Project/File: 35849 - Hereford Urban Village

**Reference: Civil and Flood Design Response to LLFA Comments for Application Ref: 251273**

### **A.1 LLFA Comments**

### **A.2 Stantec's response on the LLFA comments raised**

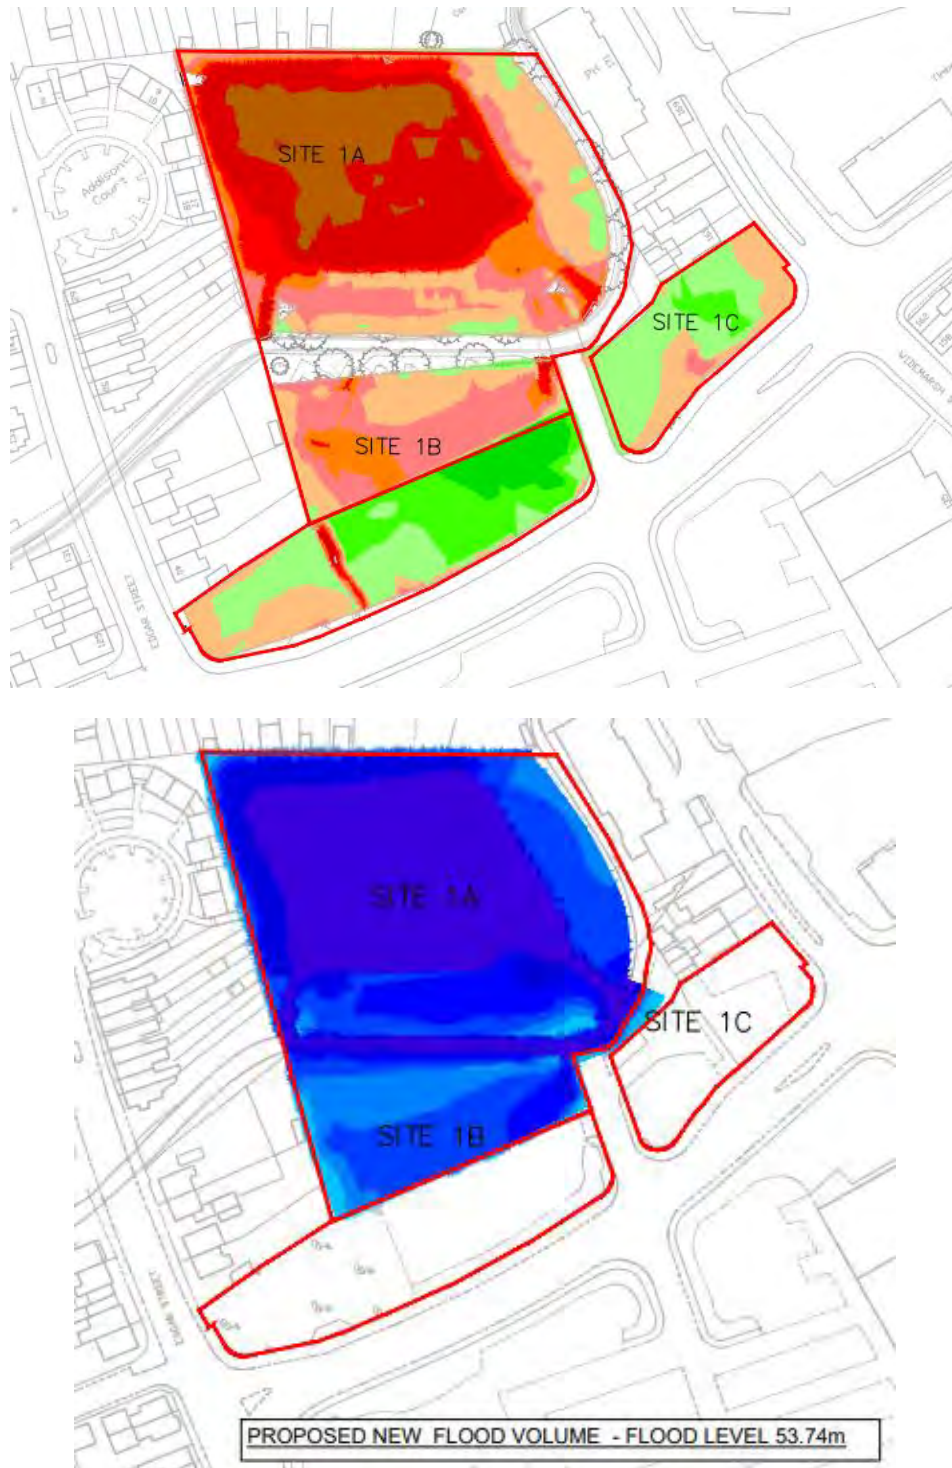
The Yazor Brook FAS was promoted in order to mobilise development within areas previously defined as Flood Zone 3B (illustrated in Blue in the pre-Yazor FAS plot below).

We note that the Cut & Fill drawing for Plots 1A,1B,1C **shows works outside of the red line boundary, which are no referenced elsewhere in the planning application**. These are the areas that have been highlighted in green (spoil is shown stockpiled).

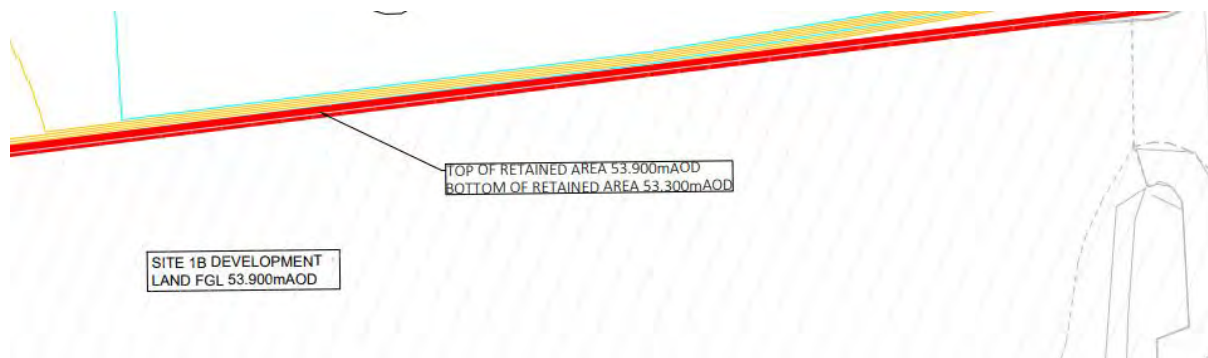
Furthermore the Proposed Contours plan for sites 1A 1B 1C includes proposed Finished Ground Levels for these plots (1B and 1C - 153.90m). The drawing suggests that there will be a retaining feature to hold the fill up.

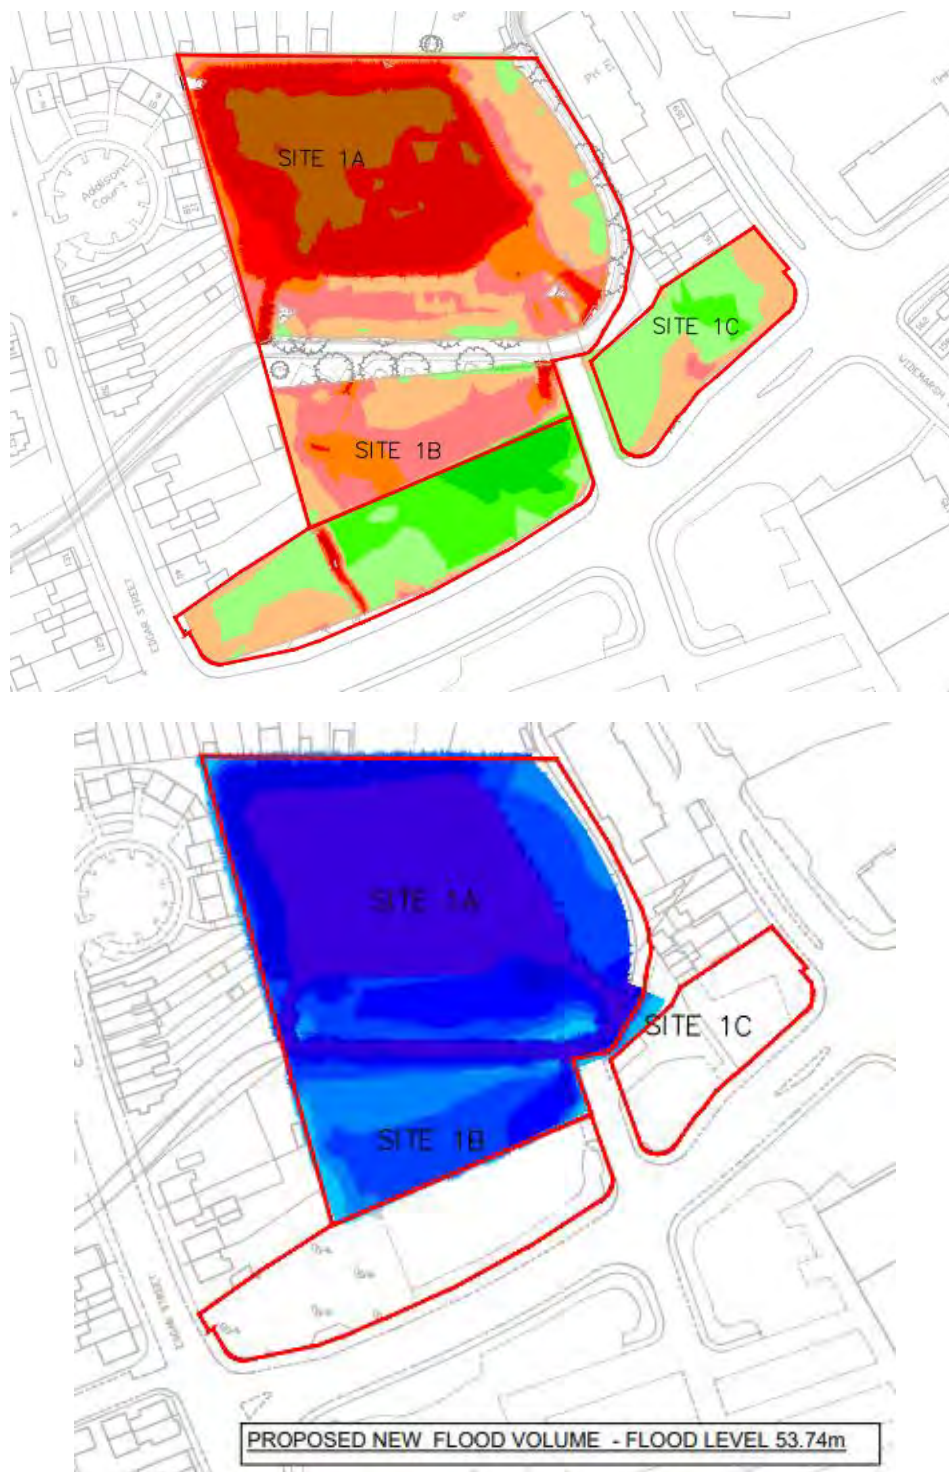
We note that the Cut & Fill drawing for Plots 1A,1B,1C **shows works outside of the red line boundary, which are no referenced elsewhere in the planning application**. These are the areas that have been highlighted in green (spoil is shown stockpiled).

The plot 1B and 1C are part of future wider masterplan application which we are also developing with HCC and these areas are only shown on cut and fill plan as a reference to understand the earthwork quantities.

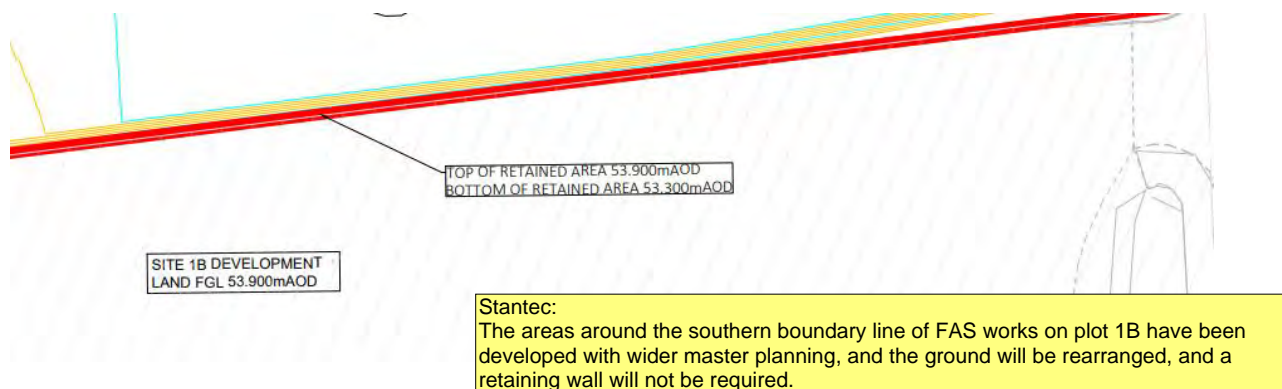
Furthermore the Proposed Contours plan for sites 1A 1B 1C includes proposed Finished Ground Levels for these plots (1B and 1C - 153.90m). The drawing suggests that there will be a retaining feature to hold the fill up.

The plot 1B and 1C are part of future wider masterplan and the consultation will take place with EA to ensure that the proposal is accepted.

The proposed FGL finished ground levels of 53.90 are set 150mm above 1:100years+CC event and the FFL are set further 150mm above the finished ground level or 300mm above the flood level. These levels are going to be discussed with EA.
